GFA AD 591

GFA AIRWORTHINESS DIRECTIVE

Replacement of the oil dipstick.

INTRODUCTION OF A NEW OIL DIPSTICK FOR ROTAX, ENGINE TYPE 912 AND 914 (SERIES)

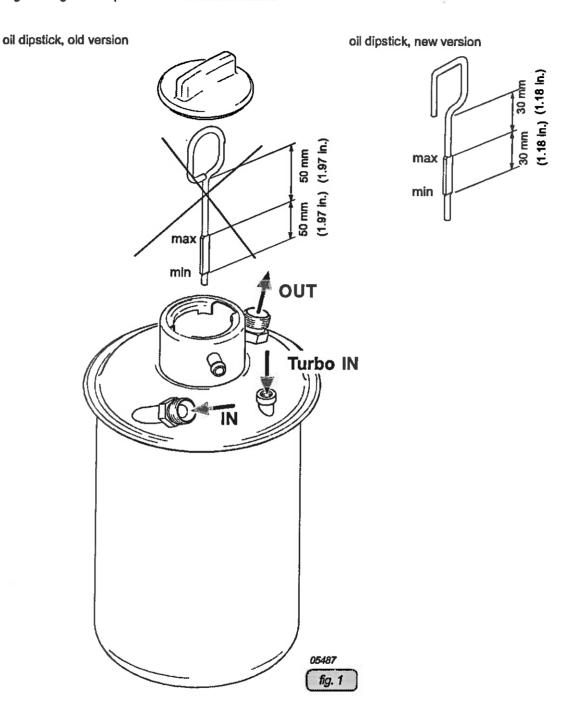
- Remove the oil dipstick part no. 956150 and replace by new oil dipstick part no. 956151.
- inspect the oil level to be performed SI-27-1997 "Oil level check", current issue.
- Add oil if necessary.
- ◆ NOTE: By changing the oil dipstick, the minimum oil level is raised by approx. 40 mm (1.57 in.) and the height between the "min." and "max." level is reduced to 30 mm (1.18 in.) (approx.0,45 litre).
- Restore aircraft to original operating configuration.
- Connect negative terminal of aircraft battery.
